Subject: FW: Weaver Dairy Residential Development

Re: Carol Woods Residents' Concerns Regarding the Proposed "Weaver Dairy

Residential" Development (P/O 9880564638)

AN ANALYSIS OF THE ASPEN HEIGHTS PARTNERS CHAPEL HILL PROPOSAL EXECUTIVE SUMMARY

Exhibit 1. Double Noise Impact on Buildings

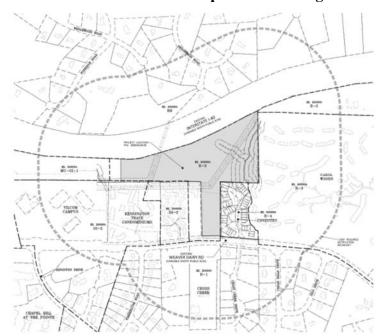
My measurements along Harkness Circle on the north end averaged 52 db. Trucks raised it to 57 dB. I do not feel comfortable checking the noise level on the proposed property. But it will be higher because it is closer to I-40, it is the same elevation as I-40, and there is a curve at the beginning of the site, which will project a higher noise because of the doppler effect.

This projected line-of-site sound will combine with the sound as cars pass, for a double hit. (See Exhibit 1.) This noise level and the poor construction noted by students below, make this building unacceptable as a place to study and converse.

"An optimal noise barrier process strives to develop a barrier that breaks the line-of-sight between receptors and the roadway noise sources." The two rows of trees shown in Figure 2 do not qualify for noise abatement.

Thus, the developer must erect a 40- or 50-feet high <u>sound absorbing</u> wall to protect residents in the apartment buildings or sound abatement materials within the apartment walls. Student feedback noted below complained of noise between apartments. A wall must be a sound absorbing wall because sound bounces over and around the usual concrete wall.
